GPU NUCLEAR

SEISMIC QUALIFICATION

No. SQ - T1 - IC - T - 0001

DESCRIPTION INTERMEDIATE CLOSED COOLING SURGE TANK

Subject <b>VERIFIKA'S CHECK.</b> <b>IC-T-1</b>	Calc No. <b>IC-T-1 SEWS</b>	Rev. No. <b>0</b>	Sheet No. <b>B4 of 5</b>
Originator <i>Handwritten signature</i>	Date <b>10-14-93</b>	Reviewed by <b>N/A</b>	Date

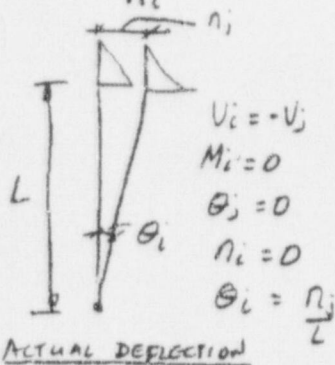
SINCE THE HEIGHT AND DIAMETER OF THE TANK IS APPROXIMATELY EQUAL AND LATERAL ACCELERATION IS SMALLER THAN 1.0, THE TANK BY ITSELF WILL NOT OVERTURN. THE NET MOMENT ABOVE THE LEGS IS ZERO. THEN THE FOLLOWING CONDITION APPLIES.

MATRIX FORMULATION FOR THIS BEAM IS  
(REF. 9, Pg. 364)

SETTING IN THE BOUNDARY CONDITIONS

$$M_j = \frac{2EI}{L^3} \left[ \frac{2 V_i L^4}{6EI} \right] = \frac{2}{3} V_i L$$

$$V_i = \frac{(\text{WEIGHT OF TANK})}{4} \times \text{SEISMIC ACCELERATION FACTOR}$$

$$V_{i2} = \frac{3830 \times 45}{4} = 431 \text{ lbs}, M_{i2} = \frac{2}{3} \times 431 \times 26.5625 = 7632 \text{ in-lb}$$

$$V_{i2} = \frac{3830 \times 68}{4} = 651 \text{ lbs}, M_{i2} = \frac{2}{3} \times 651 \times 26.5625 = 11530 \text{ in-lb}$$

Subject VERIFICATION CHECK IC-T-1	Calc No. IC-T-1 SEISM	Rev. No. 0	Sheet No. 85 of 5
Originator H. Anderson	Date 10-14-93	Reviewed by N/A	Date

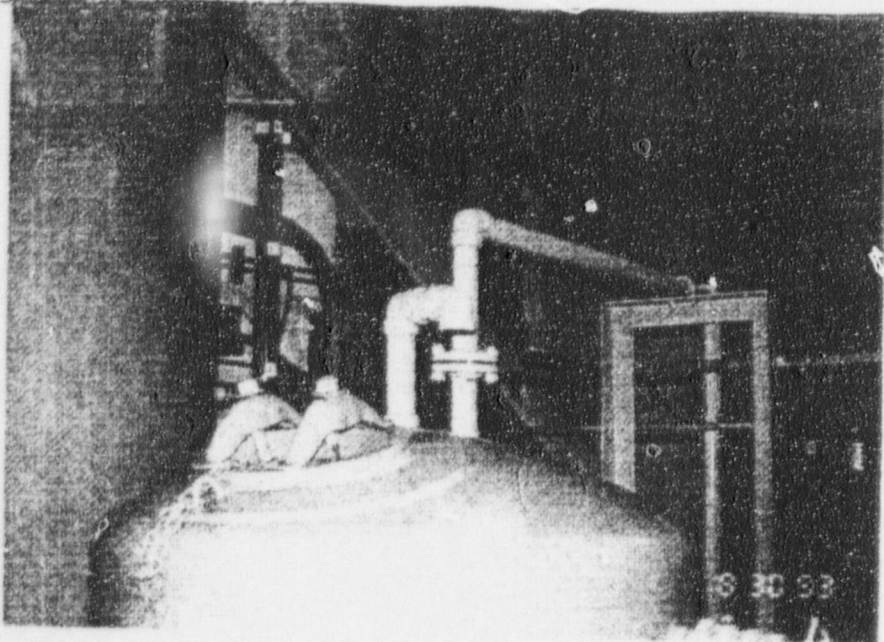
$$\text{COMPRESSION IN EACH LEG} = (431 + 651) \frac{26.5625}{32.5} + \frac{3830 \times 1.37}{4}$$

$$= 2196 \text{ lbs}$$

$$\text{CHECK } L3 \times 3 \times 3/8. \quad A = 2.11 \text{ in}^2, \quad S = 0.888 \text{ in}^3, \quad r = .587$$

$$f_a = \frac{2196}{2.11} = 1.04 \text{ ksi}, \quad f_b = \frac{7.63 + 11.53}{0.888} = 21.6 \text{ ksi}$$

$$\frac{K L}{r} = \frac{2 \times 26.5625}{0.587} = 91, \quad F_a = 14.09 \text{ ksi}$$

$$\text{FOR SEISMIC, } \frac{f_a}{F_a} = \frac{1.04}{14.09} = 0.07 < 0.15$$

$$\text{INTERACTION} = \frac{0.07}{1.6} + \frac{21.6}{6 \times 36 \times 1.6} = 0.67 < 1.0$$

OK.

CONCLUSION THE TANK LEGS ARE STRUCTURALLY ADEQUATE.
